MANOR PLANNING & ZONING
COMMISSION MEETING
AGENDA
105 E. EGGLESTON STREET
MANOR, TEXAS 78653
SEPTEMBER 14, 2016 · 6:30 P.M.

Re: Stonewater North Subdivision
Fourth Preliminary Plan Application Submittal
City of Manor

Re: Stonewater North Subdivision
Fourth Preliminary Plan Submittal Review
City of Manor

Re: Stonewater North Subdivision
Fifth Preliminary Plan Submittal Review
City of Manor

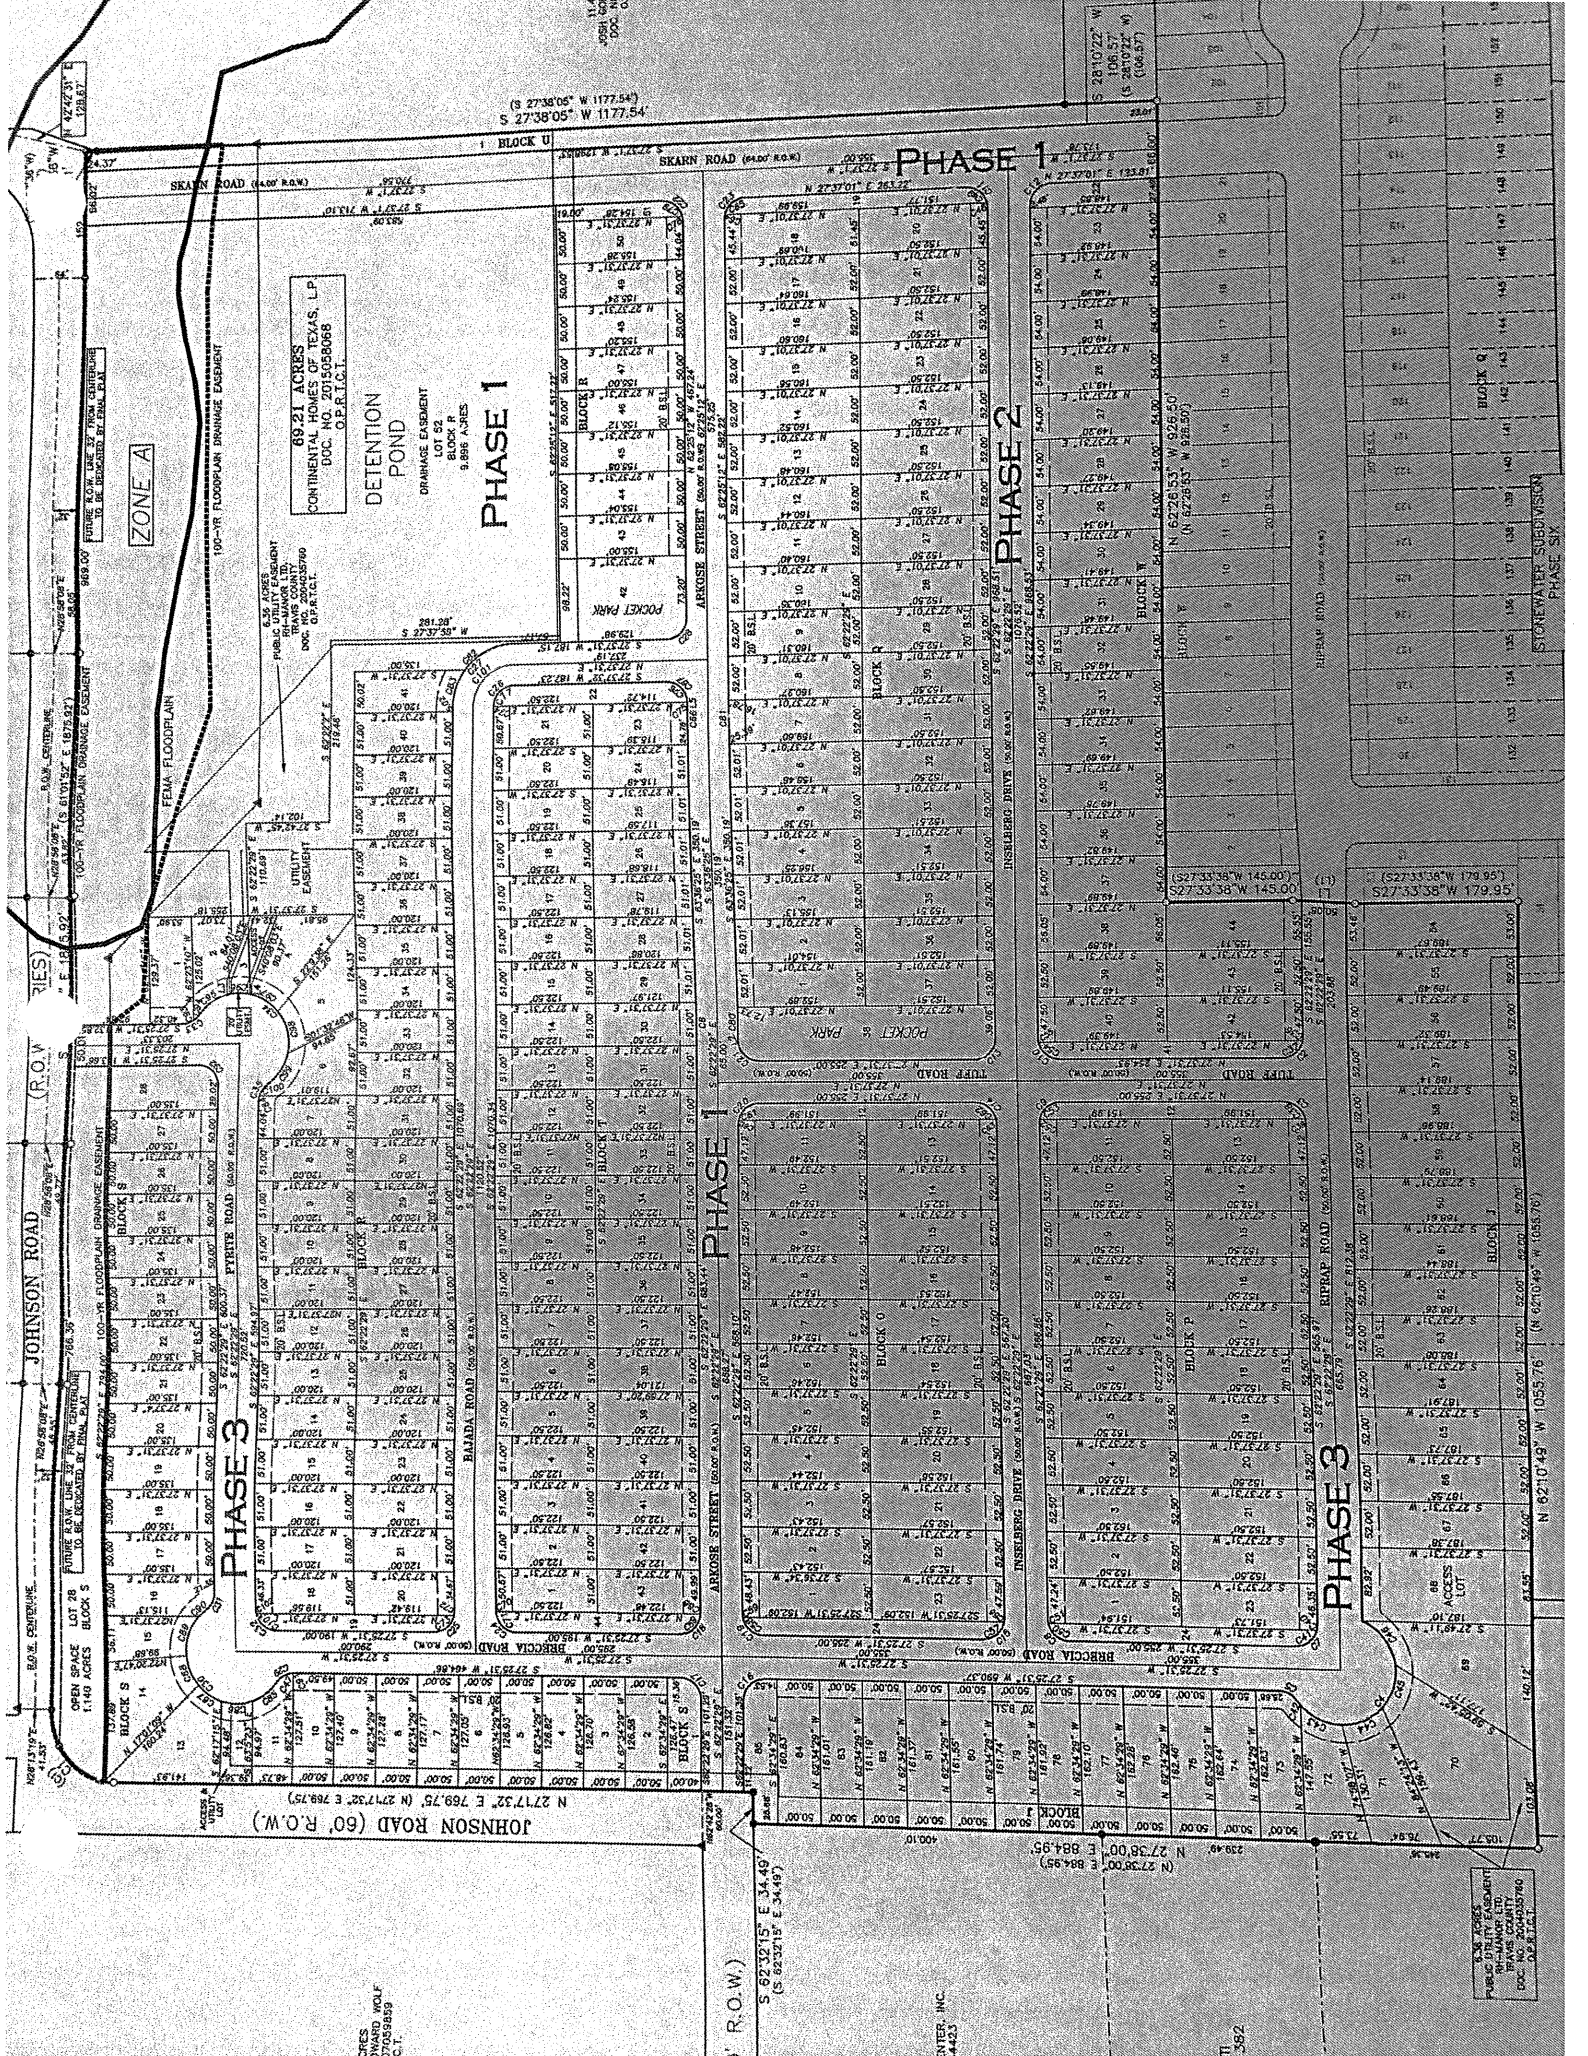
3. **Arkose Road should be stubbed out to the east to the adjacent property. The stubout is not shown on Sheet 2 – Stonewater North Preliminary Plat.**

11. Lot 87 on Block J is no longer open space due to the existing road no longer being removed with the proposed project. It should be reclassified.
12. The proposed access road to Rose Hill Cemetery has been removed from the plans. This access road was proposed to bring better access to the cemetery via Stonewater North. Written approval from the Rose Hill Cemetery Association stating that no longer providing the new access road for the cemetery is okay with the Rose Hill Cemetery Association is required.

Response: The intersection of Arkose Road and Skarn Road has been changed from a tee intersection to a four way intersection in order to incorporate a street stub out to the East property.
